Subject: Juniper Ridge Landfill Expansion Application, MEDEP #S-020700-WD-BI-N Follow-up to Department Staff's Responses to the March 4, 2016 Submittal on Staff's Review Comments as Presented in the Department's April 5, 2016 Letter

BGS AND NEWSME'S RESPONSE TO MEDEP'S APRIL 1, 2016 TECHNICAL MEMORANDA

I. April 1, 2016 Technical Memorandum Authored by Mr. Richard Behr

\\server1\CFS\Casella\OldTownLandfill\Expansion\9.35\MCY-Expansion\Project Regulatory Review\Acad\Figures\PumpTests-BR-TILL.dwg, 5/11/2016 12:47:54 PM, paf

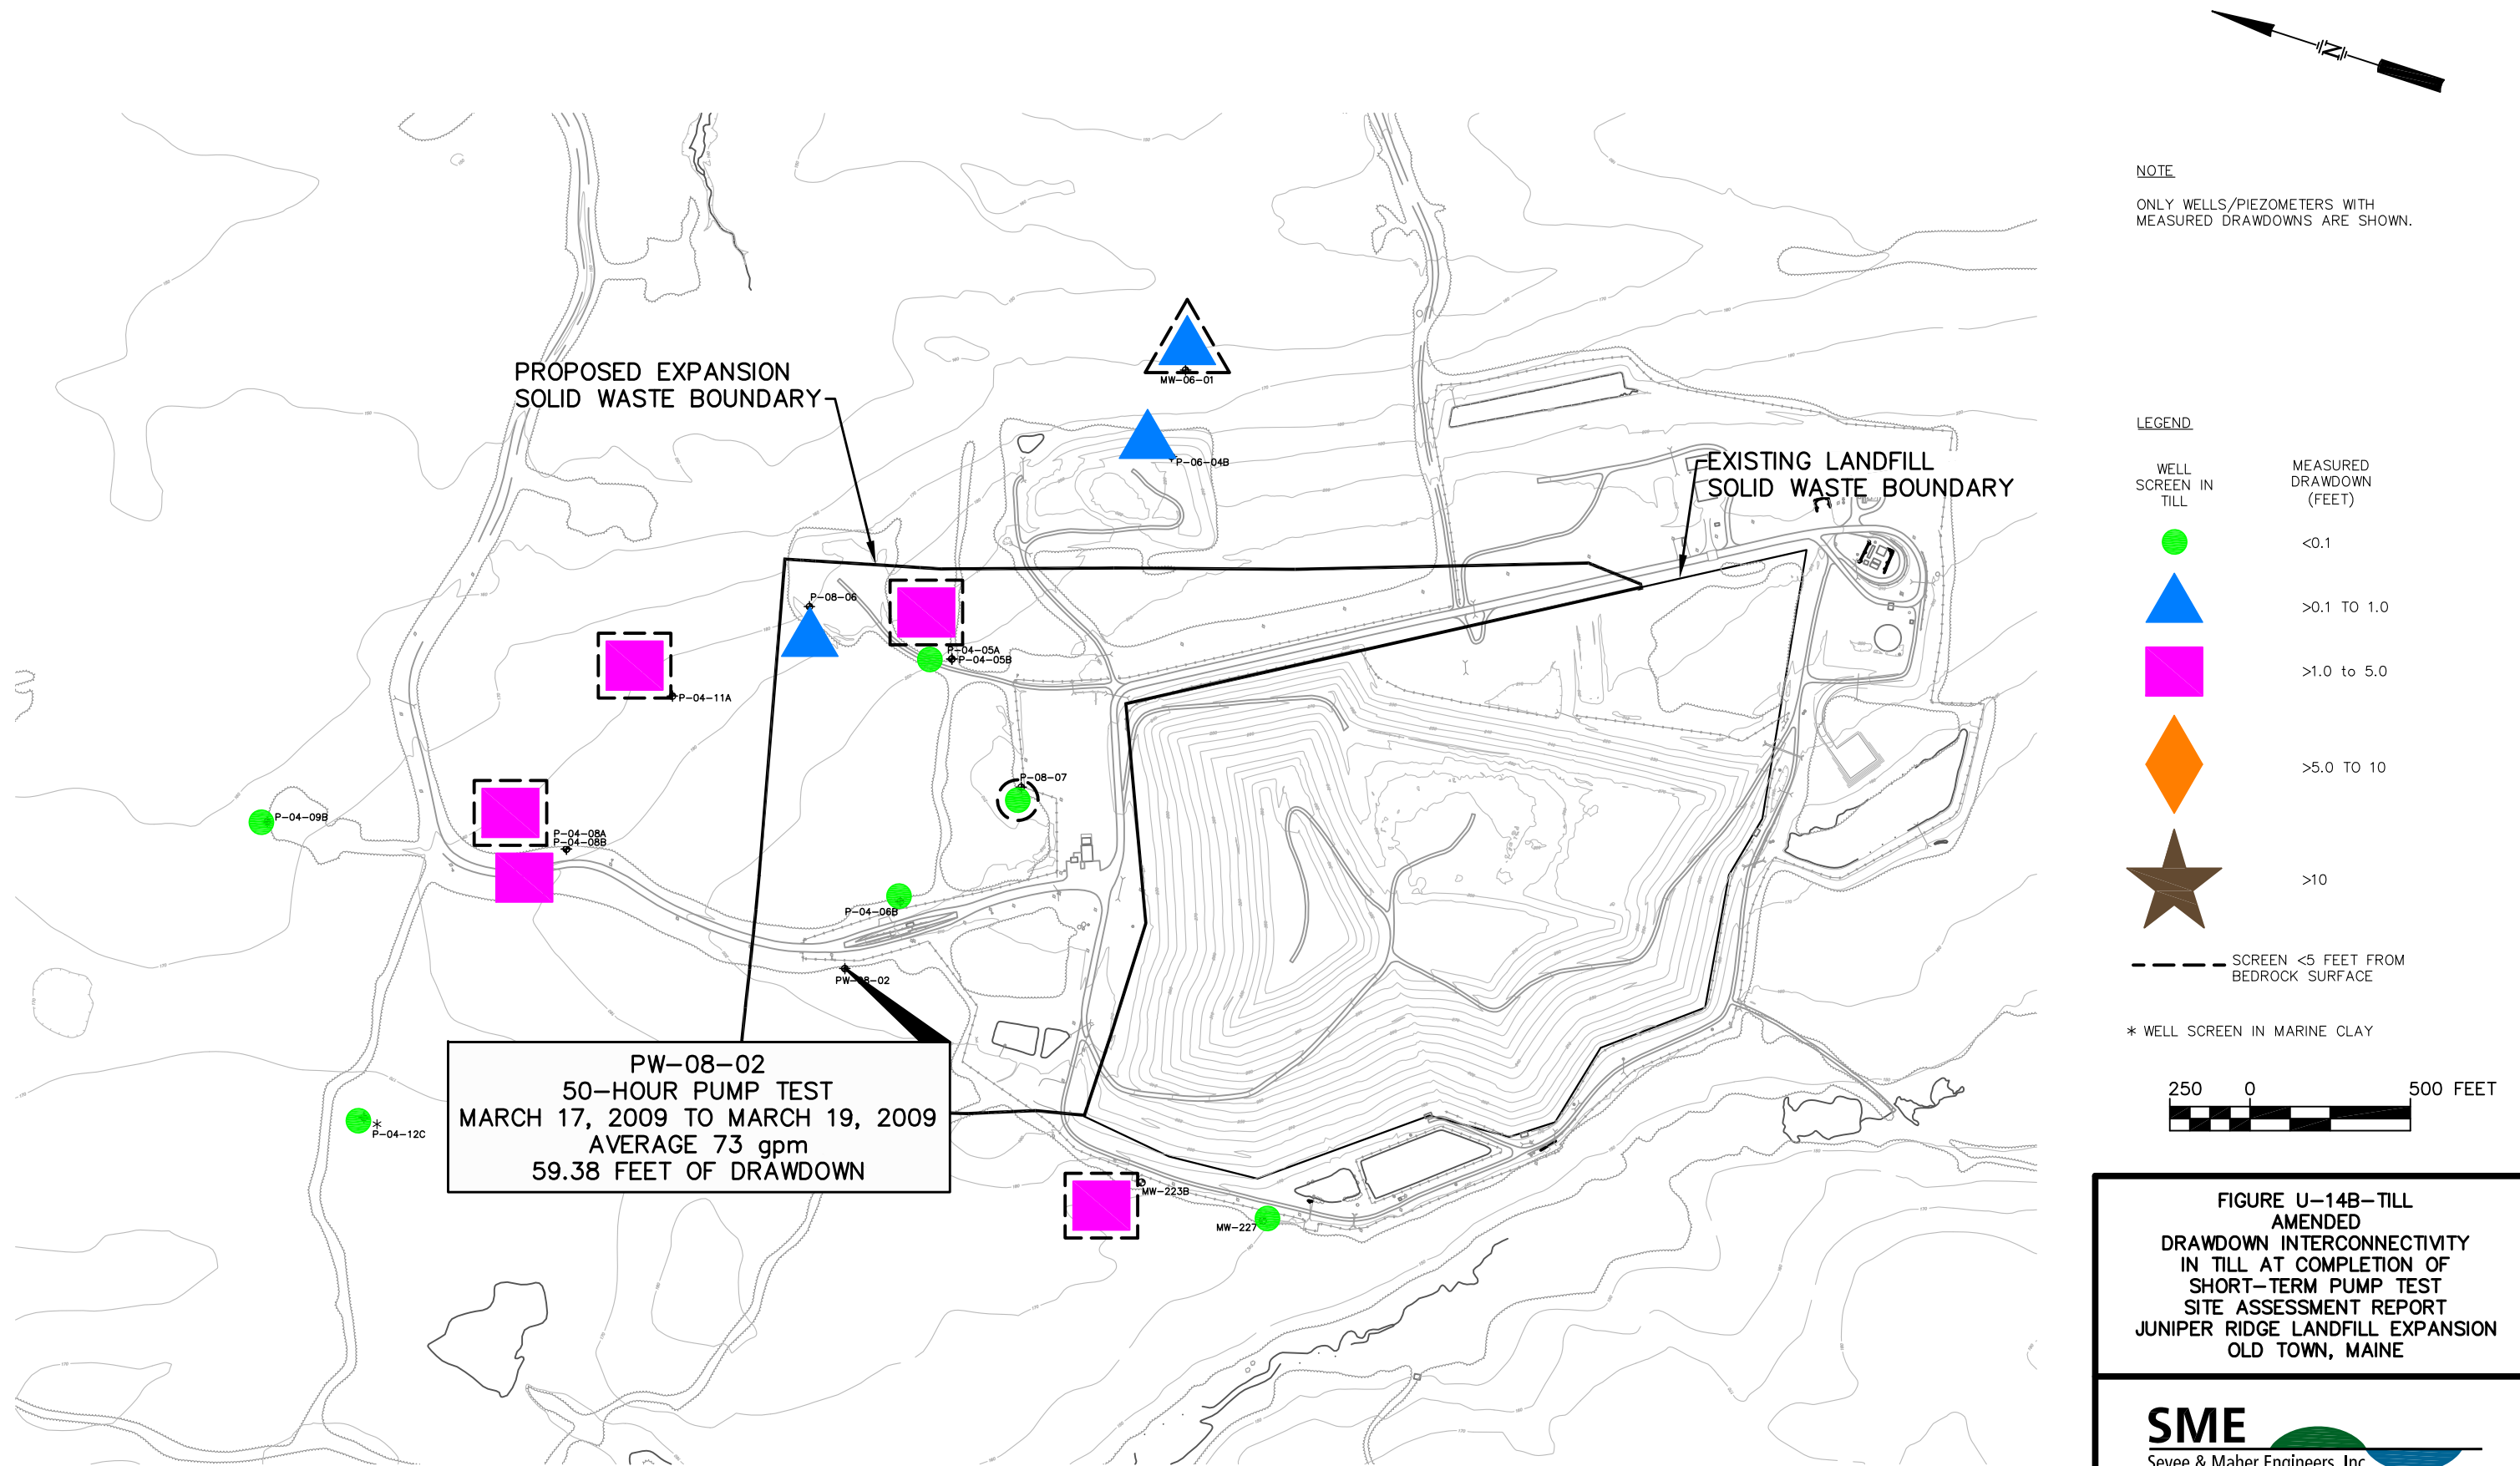
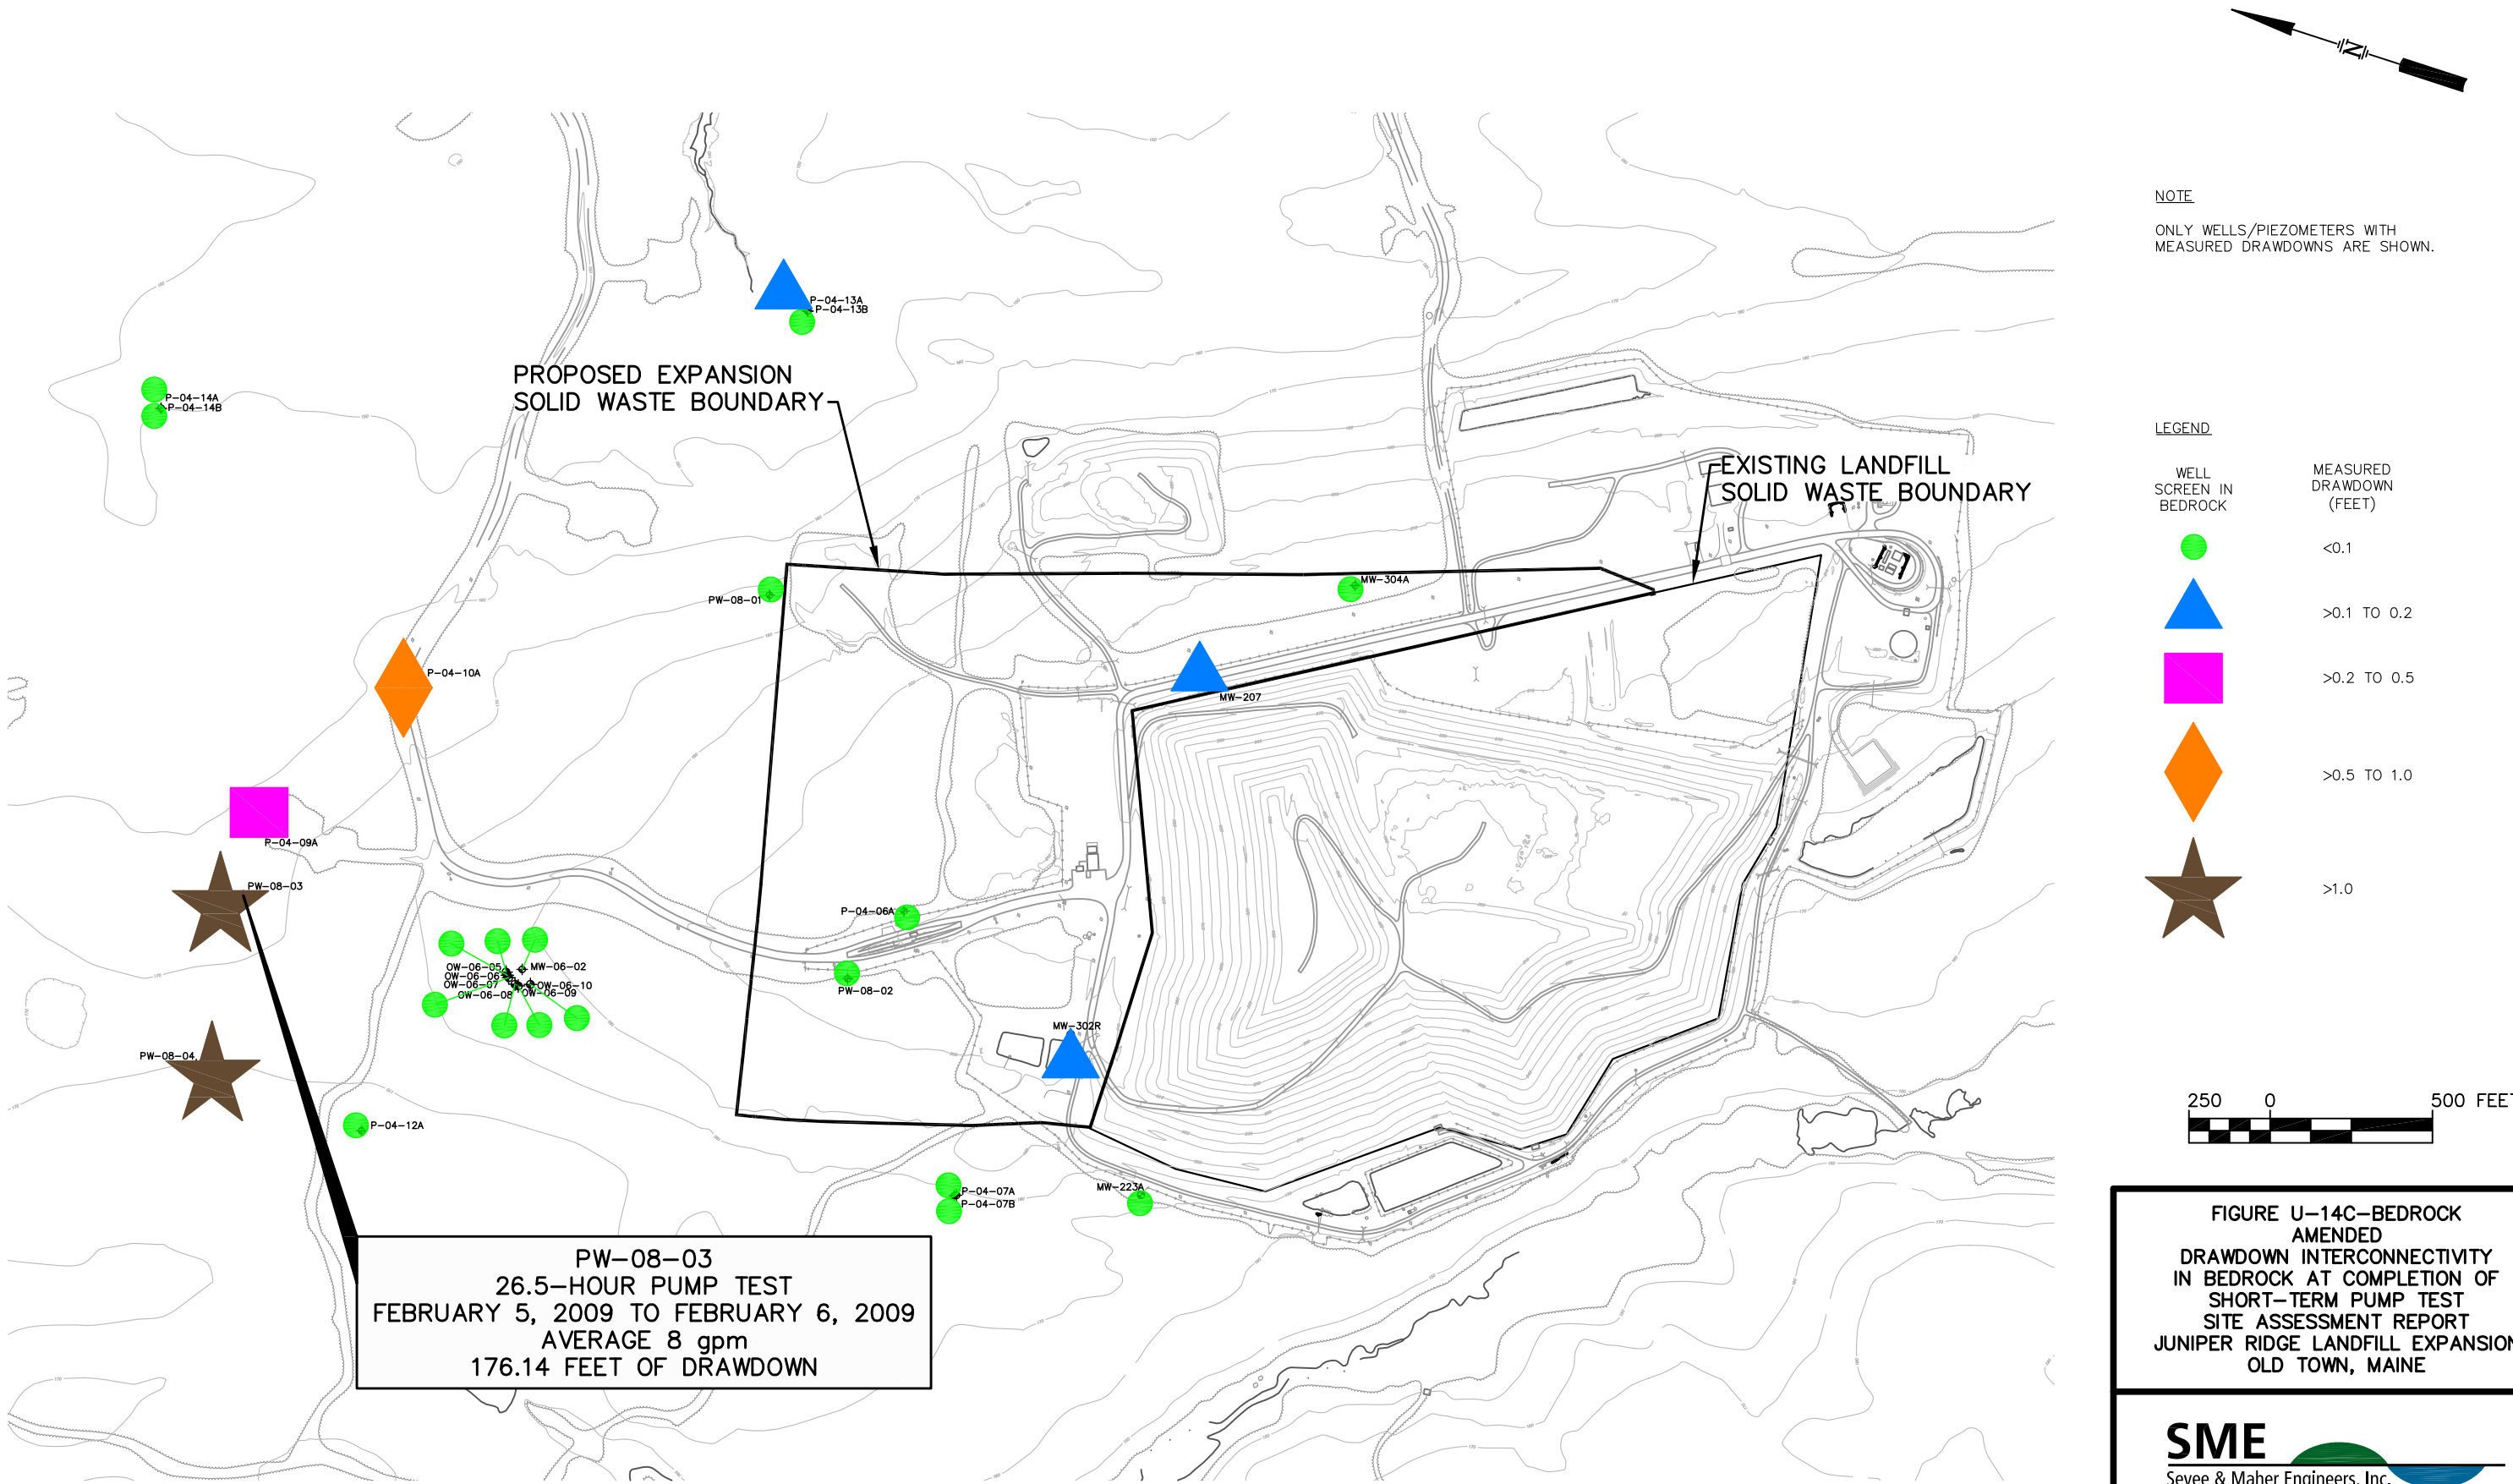
MEDEP Follow-on Response: My original comment included a request for figures to illustrate the observed drawdowns in monitoring wells screened in the till. JRL's

response did not include the requested figures. I continue to assert that a graphic depiction of locations where the till is hydraulically connected to the underlying bedrock is important and may assist in locating wells for long term monitoring and extraction wells in the unlikely event a significant leachate release were to occur.

MEDEP – Follow-on Response: The referenced figures were included in the original application but they do not differentiate the till wells from the bedrock wells. I continue to believe JRL should produce figures that depict the till wells where drawdowns were observed during the long-term pumping tests. These figures may help in the evaluation of long term monitoring well locations.

MEDEP – Follow-on Response: JRL's response to my comments about Figures U-14 and U-15 do not adequately address my comments. Additional figures are needed to properly illustrate the data collected during each of the five pumping tests. To further enhance the results of the pumping test data, it is necessary to include all of the drawdown data obtained during each test. Again, I contend it is important to differentiate between bedrock and till wells. As an example, the figure (Figure U-14) illustrating the 26.5 hour pumping test performed on PW-08-04, uses graduated symbols to depict the range of observed drawdowns for only 20 of the 53 wells where water levels were observed. There are also apparent inaccuracies on the existing figures. The text on page 26 states six wells (5 bedrock and 1 till) experienced between 0.1 and 1.0 foot of drawdown although Figure U-14 only depicts three wells in this range. The figure (Figure U-15) depicting the drawdowns observed during the long-term pumping tests at PW-08-01 and PW-08-02 also requires revisions as only a fraction of the drawdown data is depicted on this figure. Although JRL collected drawdown data for 53 wells during the tests, Figure U-15 only depicts data for 21 wells.

To address these comments, I recommend JRL display all of the drawdown data for each pumping test on appropriately scaled figures. I also ask JRL to augment the drawdown data included in Appendix M with a table summarizing the total drawdown observed in all wells during each of the pumping tests. This table would include those wells instrumented with pressure traducers and those where manual water levels were made. I am certain JRL has previously compiled this data to complete the pumping tests analyses. I also request that JRL also provide the Department with an electronic copy of the spreadsheet.

Applicants' Response: Included in Attachment SME-D3 are ten figures augmenting Figures U-14 and U-15 included in Appendix U of Volume II of the Application. These figures show monitoring wells and piezometers where drawdowns were measured during the pumping tests. For each pumping test two figures, one showing the drawdown in the bedrock, and one showing the drawdown in the till, have been prepared. On the figures showing the drawdowns in the till the locations where the instrument screen is located within five feet of the bedrock surface are identified.

Applicants' Response: See previous response to the comment regarding Appendix U, Pg 25, 5.0 Pump Test Proof of Bedrock Interconnectivity. These figures are contained in Attachment SME-D3.

Applicants' Response: See previous response to the comment regarding Appendix U, Pg 25, 5.0 Pump Test Proof of Bedrock Interconnectivity. The augmented U-14 and U-15 figures are contained in Attachment SME-D3.
